**Device** TC1767  
**Marking/Step** EES-AD, ES-AD, AD  
**Package** PG-LQFP-176-5

## 01704AERRA

This Errata Sheet describes the deviations from the current user documentation.

**Figure 1 Timing concerning equidistant multiple timers**

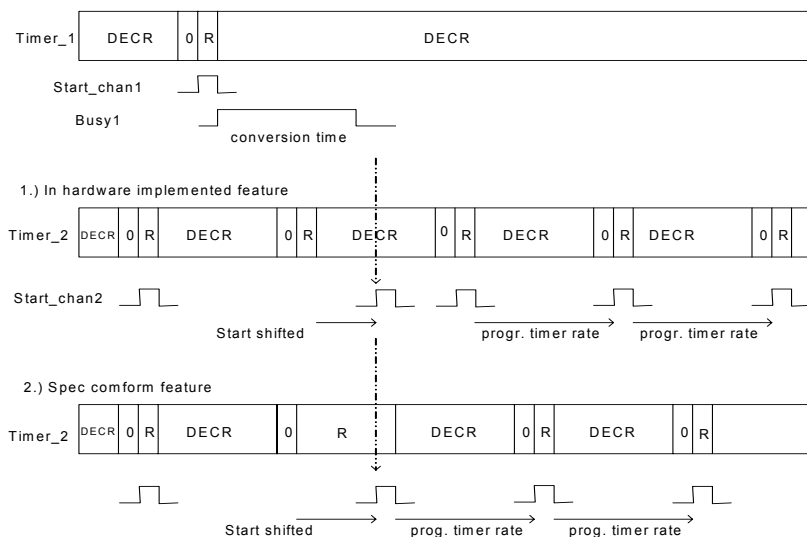
The description is an example for timer\_1 and timer\_2, but can also affect all other combinations of timers.

Timer\_1 and Timer\_2 are running with different reload-values. Both timers should start conversions with the requirement of equidistant timing.

Problem description:

Timer\_1 becomes zero and starts a conversion. Timer\_2 becomes zero during this conversion is running and sets the conversion-request-bit of channel\_2. At the end of the conversion for channel\_1 this request initiates a start for channel\_2. But the Timer\_2 is reloaded only when setting the request-bit for channel\_2 and is decremented during the conversion of channel\_1.

The correct behavior would be a reload when the requested conversion (of channel\_2) is started.

Therefore the start of conversion for channel\_2 is delayed by maximum one conversion-time. After this delay it will be continued with equidistant conversion-starts. Please refer to the following figure.

**Figure 2 Loss of Arbitration**

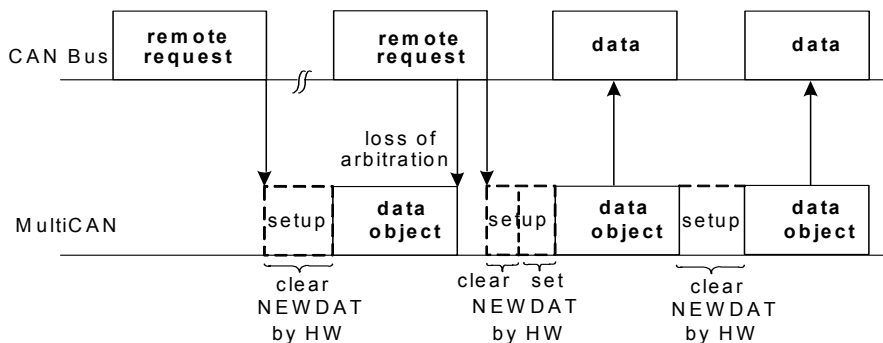
When the appropriate message object (data frame) triggered by the first remote frame wins the arbitration, it will be sent out and NEWDAT is not reset. This leads to an additional data frame, that will be sent by this message object (clearing NEWDAT).

There will, however, not be more data frames than there are corresponding remote requests.
